Well Name: MCKENZIE	Well Location: T30N / R12W / SEC 20 / NWNW / 36.803619 / -108.125824	County or Parish/State: SAN JUAN / NM
Well Number: 1E	Type of Well: CONVENTIONAL GAS WELL	Allottee or Tribe Name:
Lease Number: NMNM024158	Unit or CA Name:	Unit or CA Number:
US Well Number: 300452360900S1	Operator: DUGAN PRODUCTION CORPORATION

Notice of Intent

Type of Submission: Notice of Intent	Type of Action: Plug and Abandonment
Date Sundry Submitted: 07/28/2025	Time Sundry Submitted: 08:08
Date proposed operation will begin: 08/11/2025

CONDITIONS OF APPROVAL

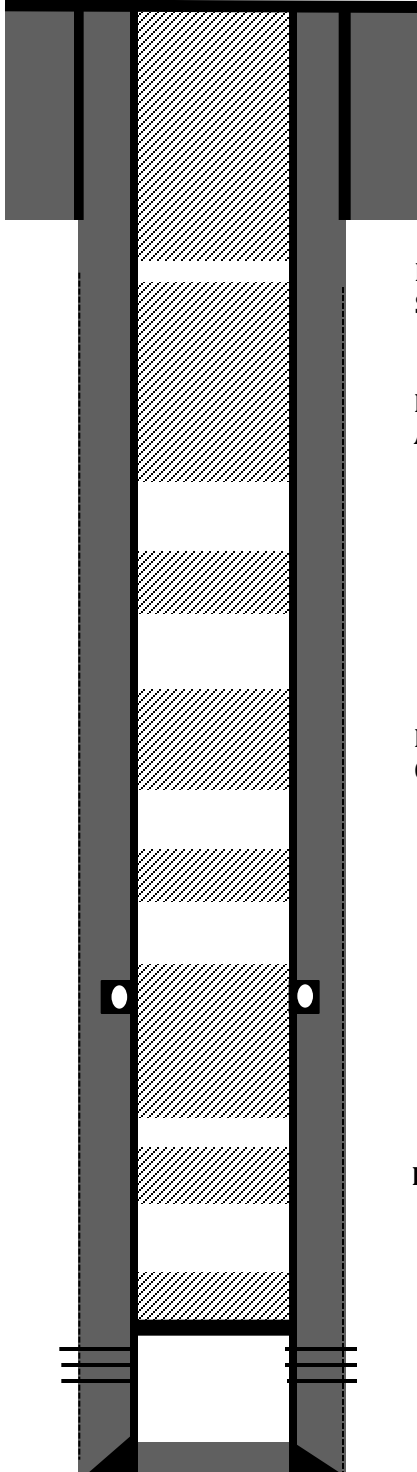
-The Dakota CIBP depth in the Planned P&A schematic, listed at 5603', is incorrect. It is listed elsewhere at 6476', which appears correct.

- a. Correct Plug 1 (Dakota/Graneros) CIBP depth on Planned P&A schematic to 6476'. Schematic currently has CIBP at 5603' but bottom of plug is 6476'.

- b. May adjust Plug 3 (Mancos/DV) BOC to 4760' to cover BLM Geologist's Mancos formation top pick @ 4710'. Plug 3 should at a minimum cover 4569' – 4760', estimated minimum 15 sx Class G.

- c. Adjust Plug 4 (Mesaverde) TOC to 3420' cover BLM Geologist's Cliffhouse formation top pick @ 3520'. Plug 4 should at a minimum cover 3420' – 3570', estimated minimum 12 sx Class G.

- d. Adjust Plug 7 (Fruitland/Kirtland/Ojo) TOC to 760' to cover BLM Geologist's Ojo Alamo formation top pick @ 860'. Plug 7 should cover at a minimum 760' – 1398', estimated minimum 50 sx Class G.
